FROM: Allied Engineering, Inc.  
160 Veranda Street  
Portland, Maine 04103  
Telephone: (207) 221-2260

RE: Addendum No. **Two (2)** to the Bidding Documents for:  
**NEW York Vehicle Storage Garage, York, ME**

This Addendum forms a part of the Contract Documents and modifies the original Bidding Documents dated March 28, 2023. Acknowledge receipt of this Addendum in the space provided on the Proposal Form. Failure to do so may subject Bidder to disqualification.

SHEET NUMBER: A-1

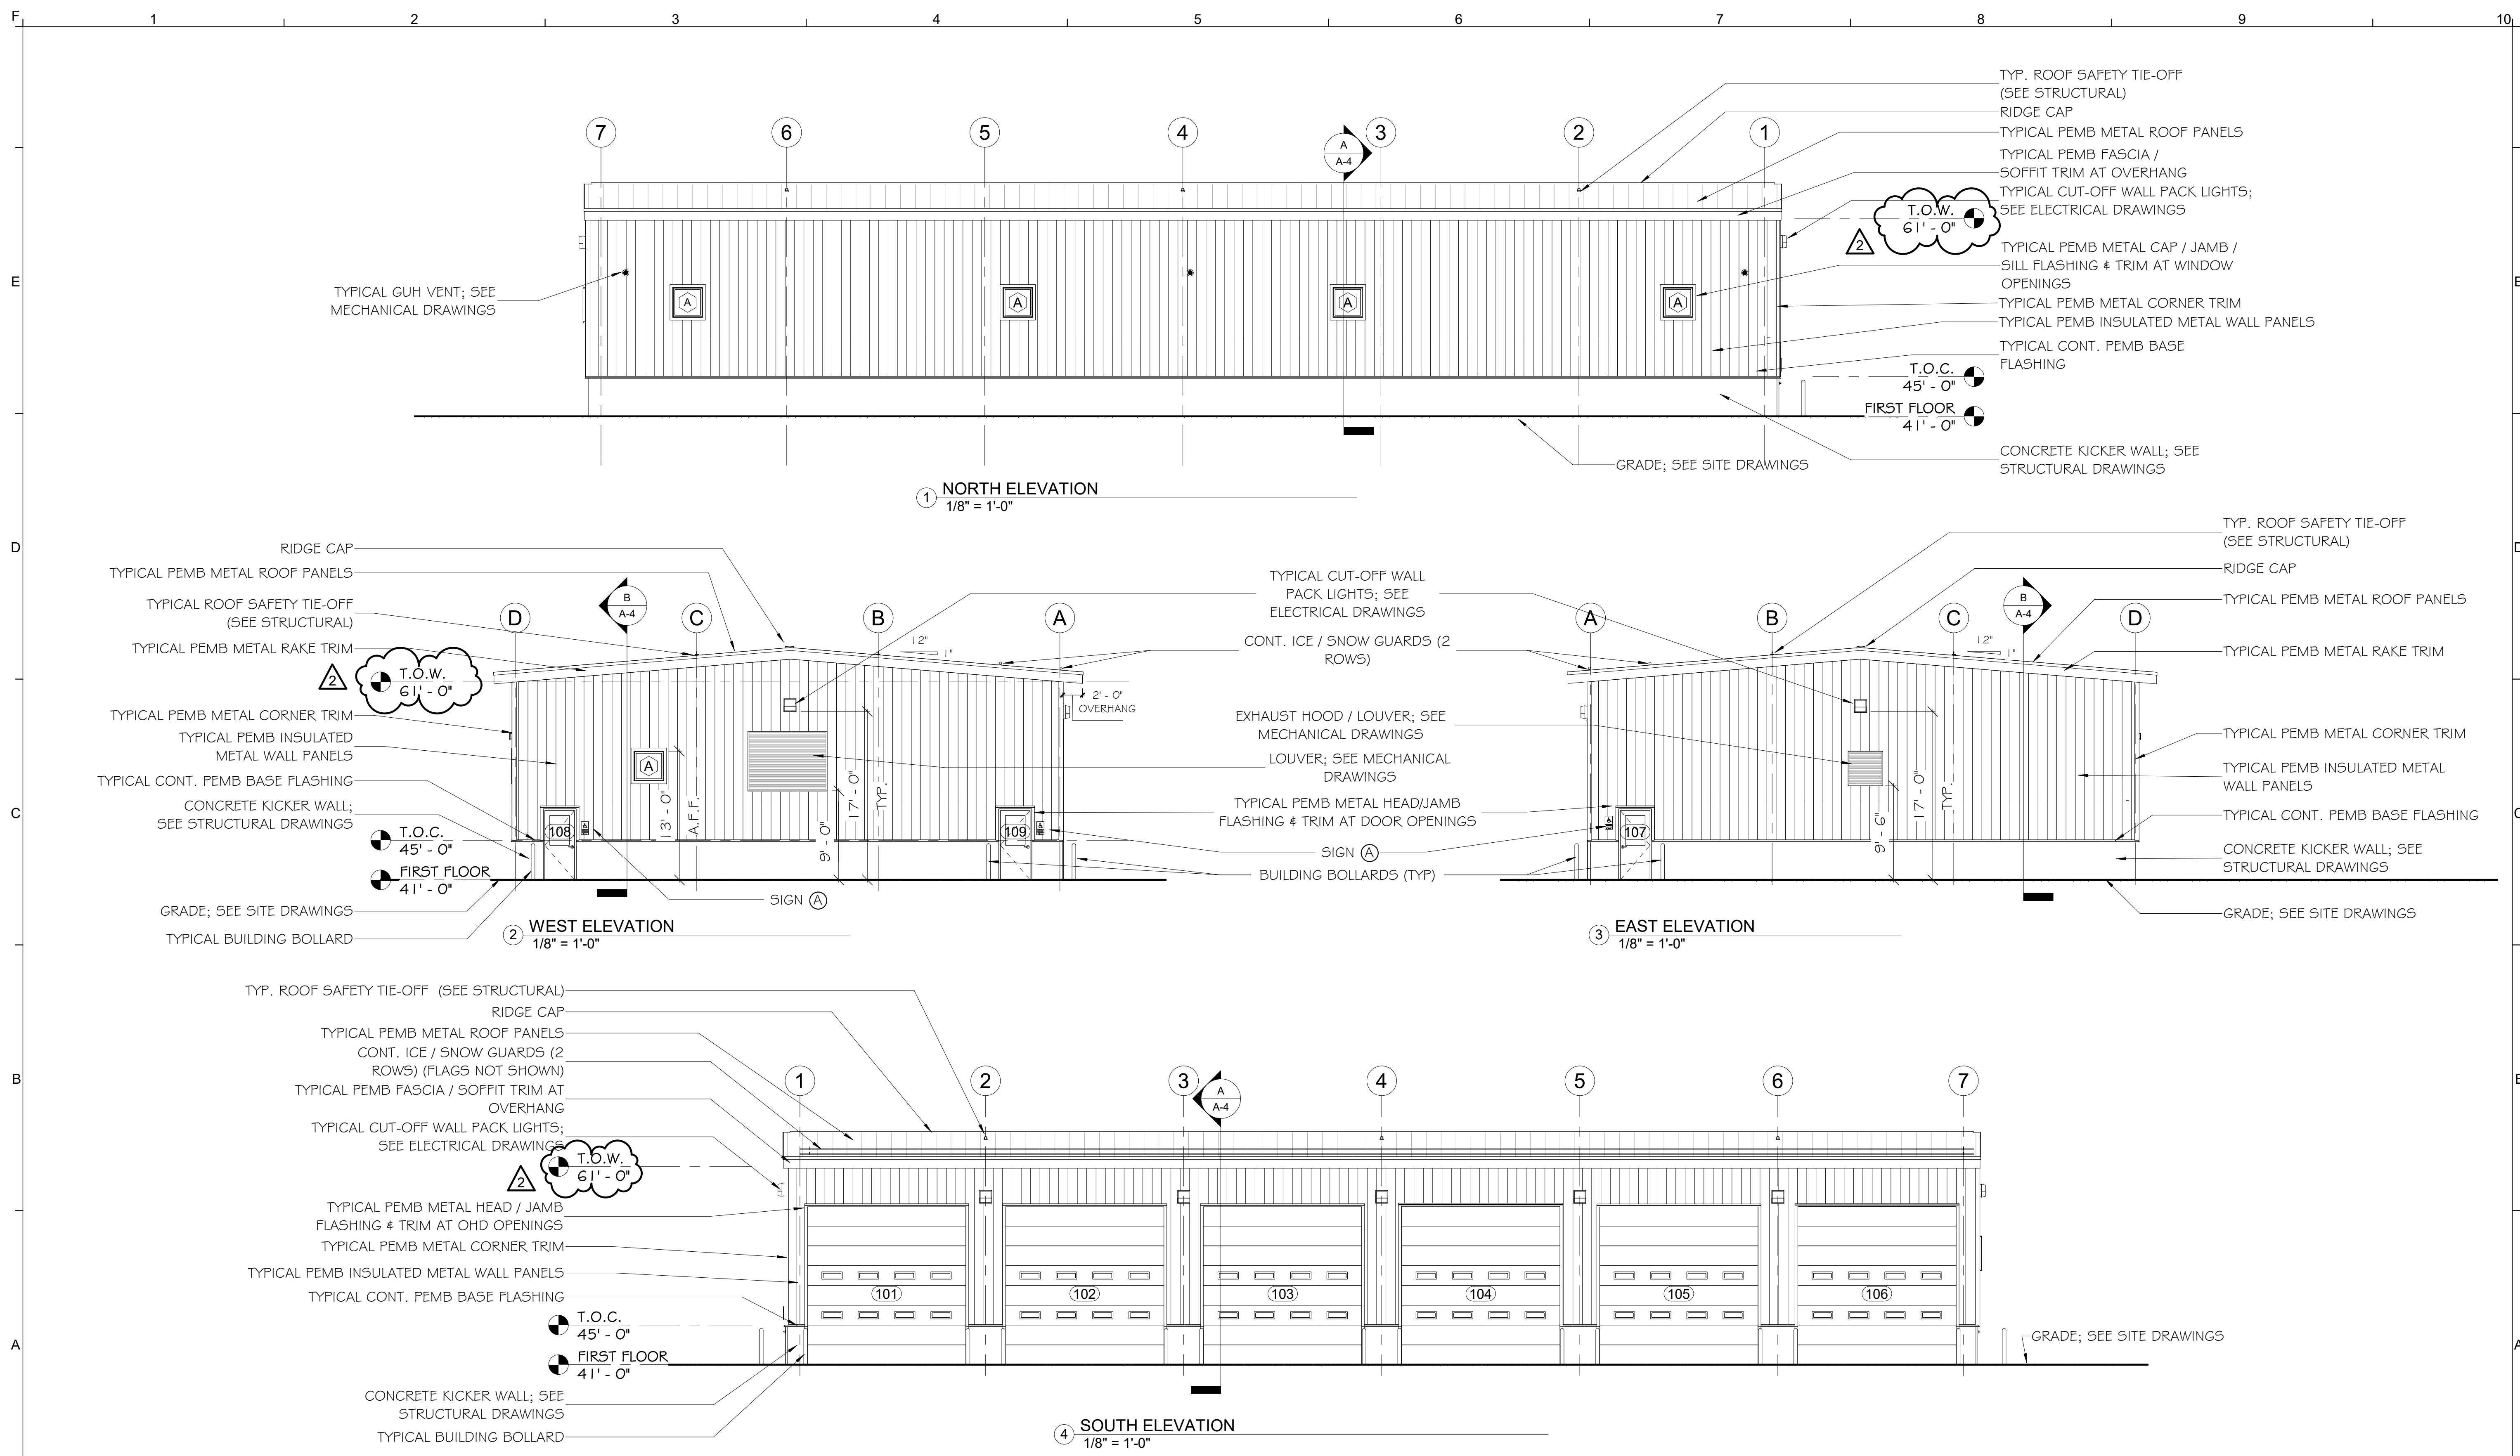
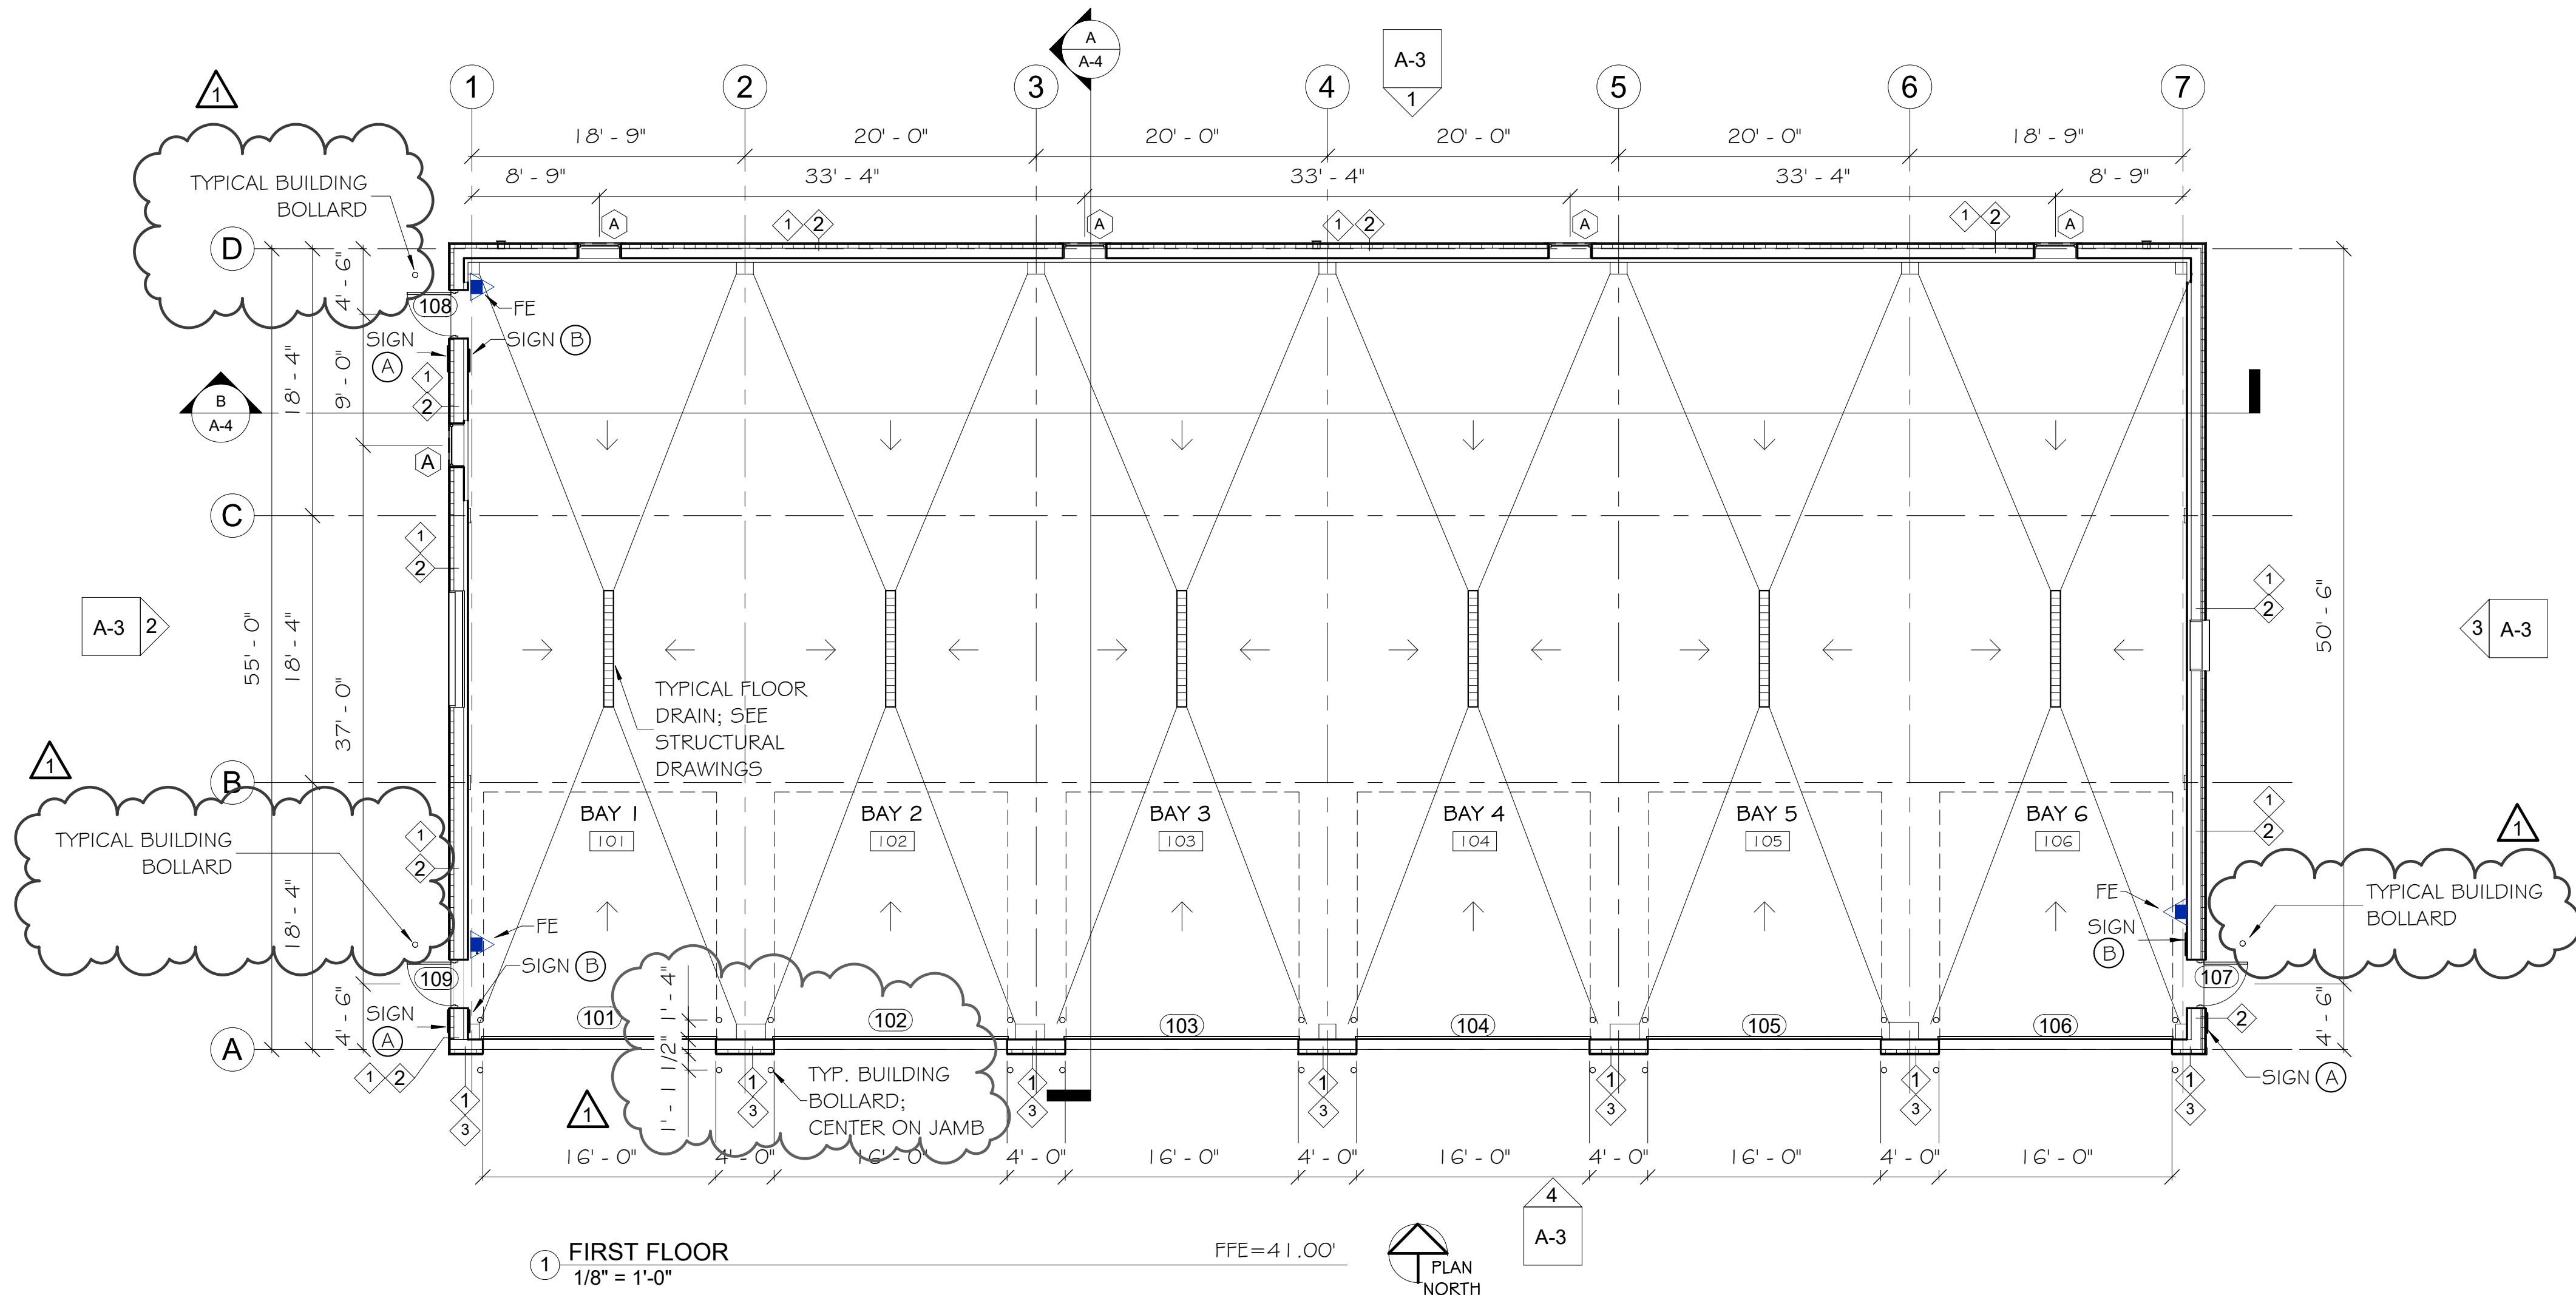
14. **Question:** Plan A-1 has “ typical building bollard” noted in 3 locations, but there is no designation for them. Are we to include bollards in these areas, and if so, would the same criteria used for the ones at the overhead doors be used?

**Response:** The 3 bollards at the pass doors are the same criteria as the bollards at the overhead doors. They are depicted on the Code Compliance Plan. They have been added to the Drawing A-1\_First Floor Plan (Revised) as well (attached).

**CONTRACT 2023.06**  
**YORK VEHICLE STORAGE GARAGE**  
**WALL SECTIONS**  
 SHEET NUMBER: A-5  
 CONTRACT: 2023.06  
 16 OF 33

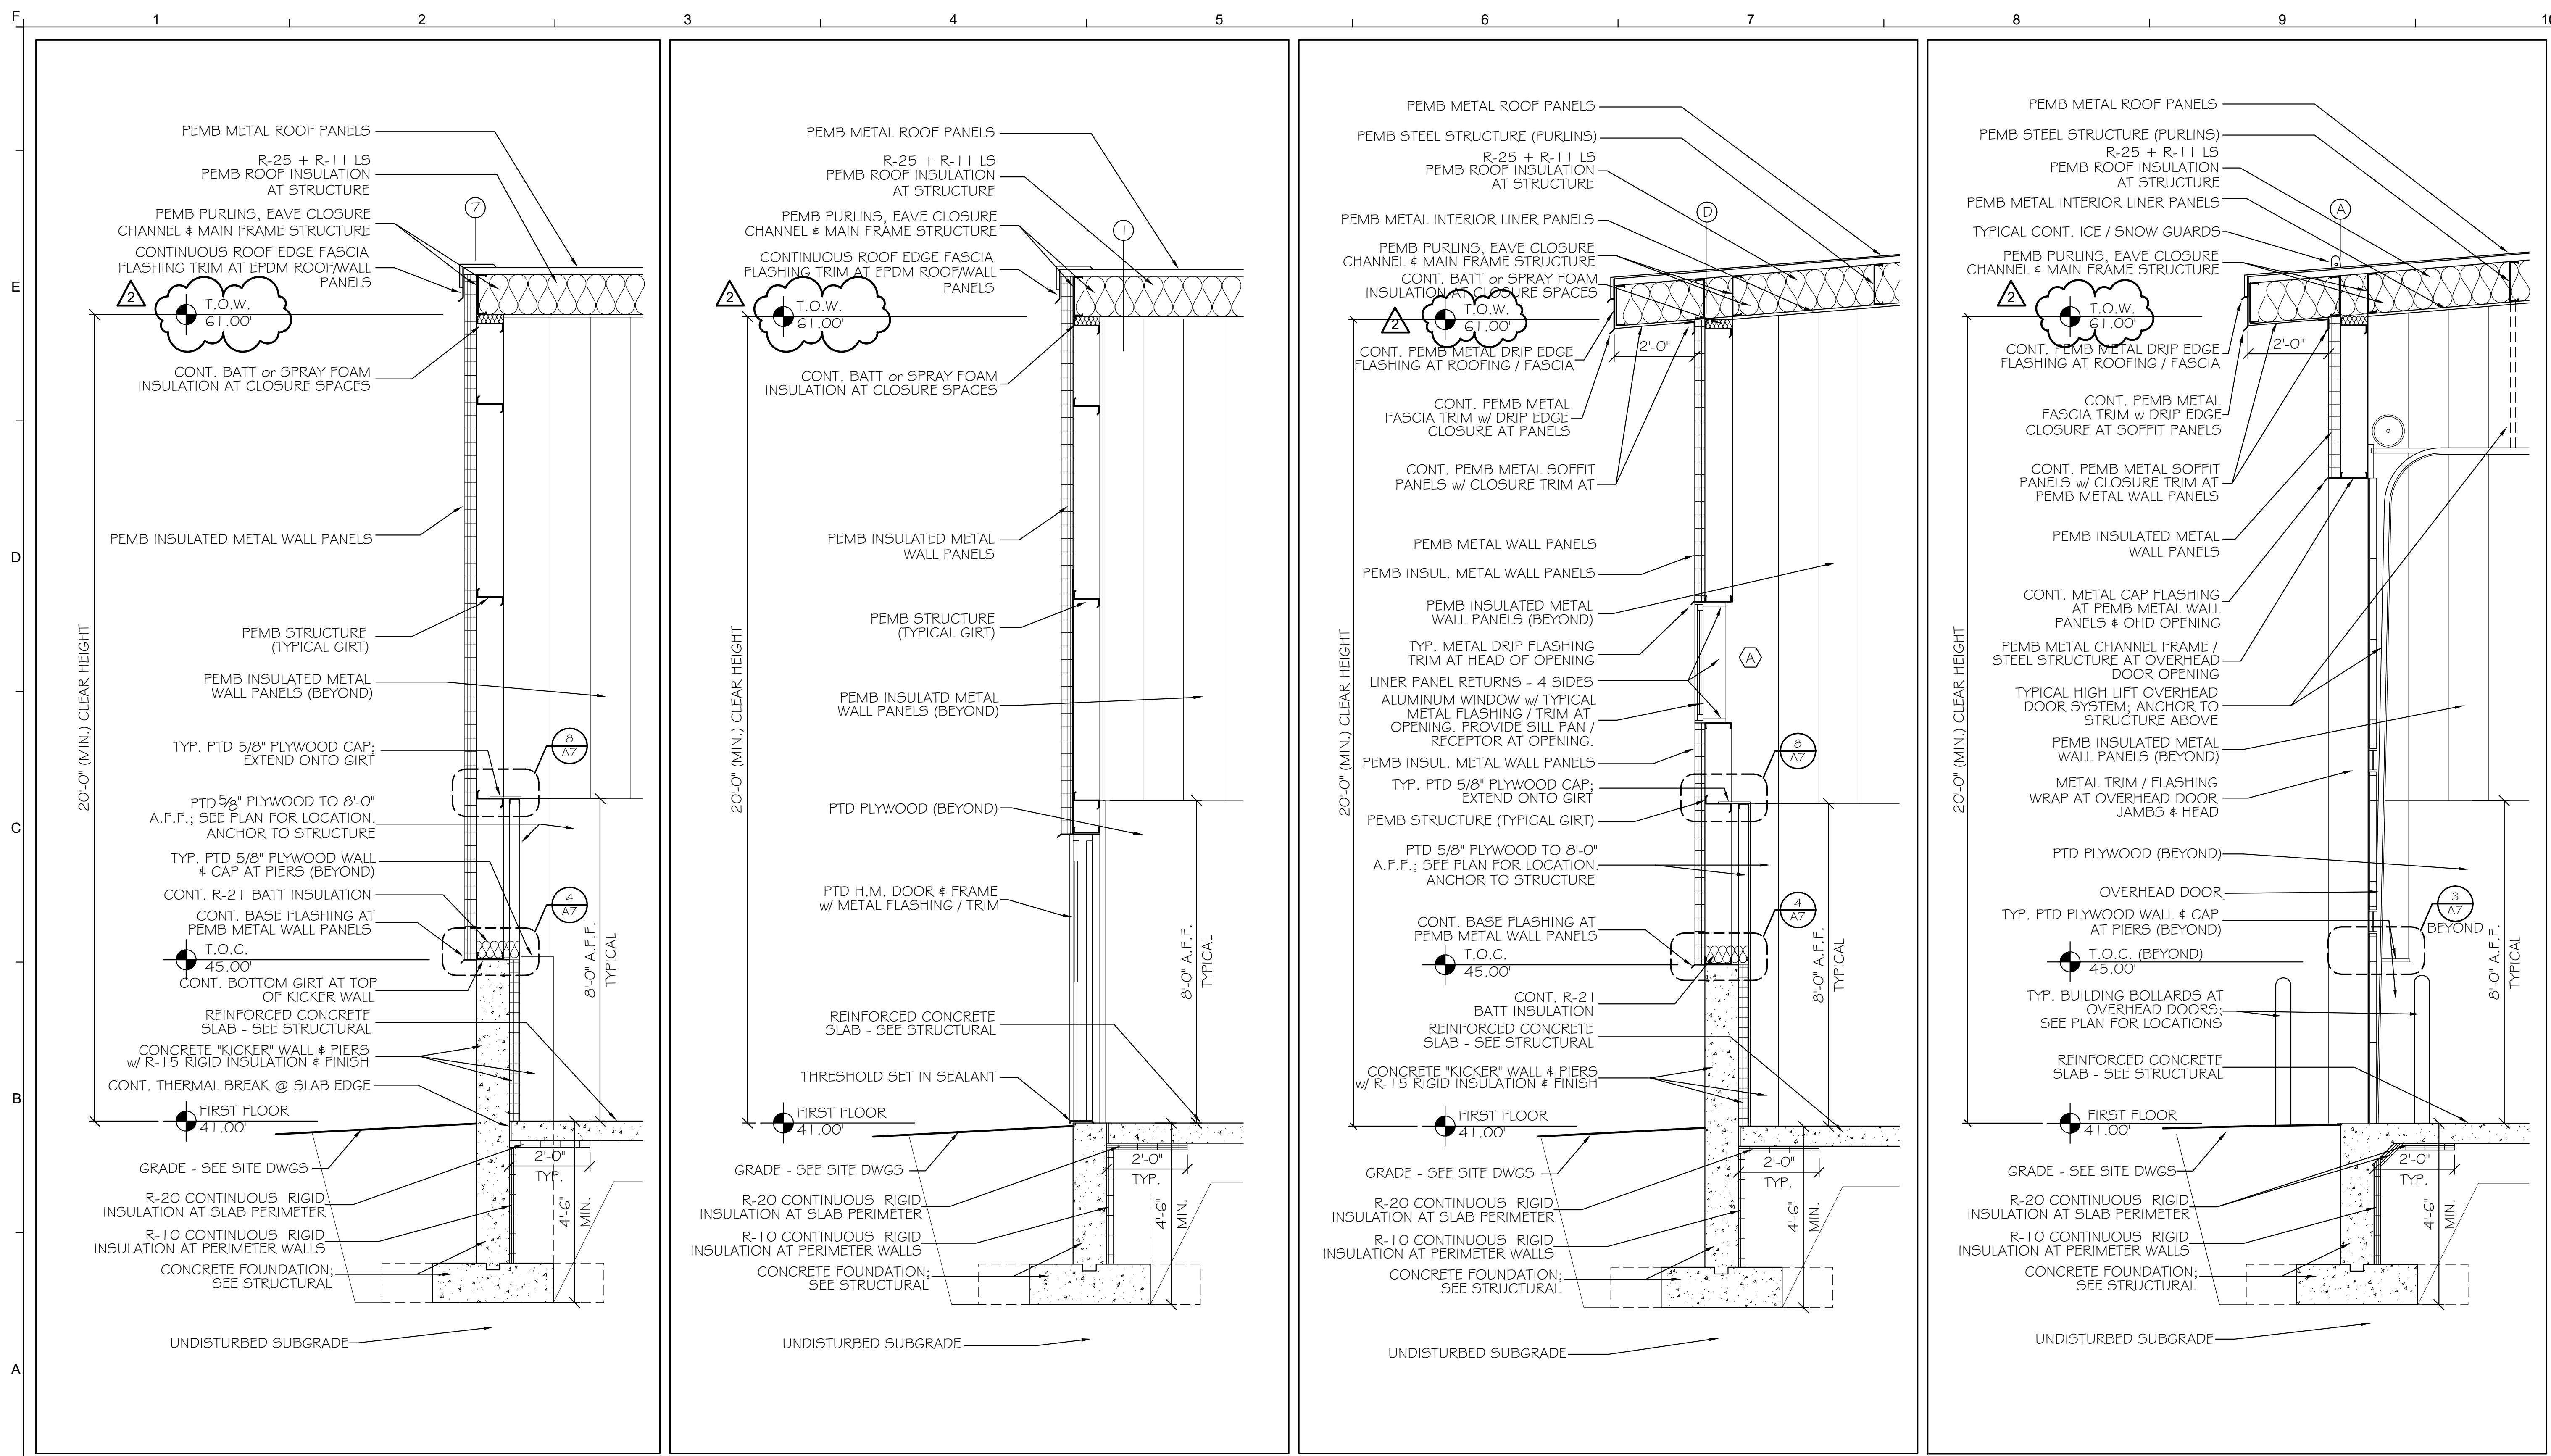
6. **Question:** In the specs they have high lifted track and jackshaft operators. If you look at sheet A-5 of the plans, Detail 4 wall section, the doors are 16' high and you have 18' to low point of ceiling. I cannot put a high lift track in here as it will be standard 15" radius. We have to use a trolley operator or maybe a slave trolley which has jackshaft operator and trolley bar.

15. **Question:** The typical clearance required for a 16’-0” overhead door is 2’-6”. An 18’-0” eave height, less depth of eave strut and depth of portal frame will cause clearance issues. Please clarify if the eave height will be increased.

**Response:** The building eave height will be changed to 20’-0” high. See attached revised A-5.
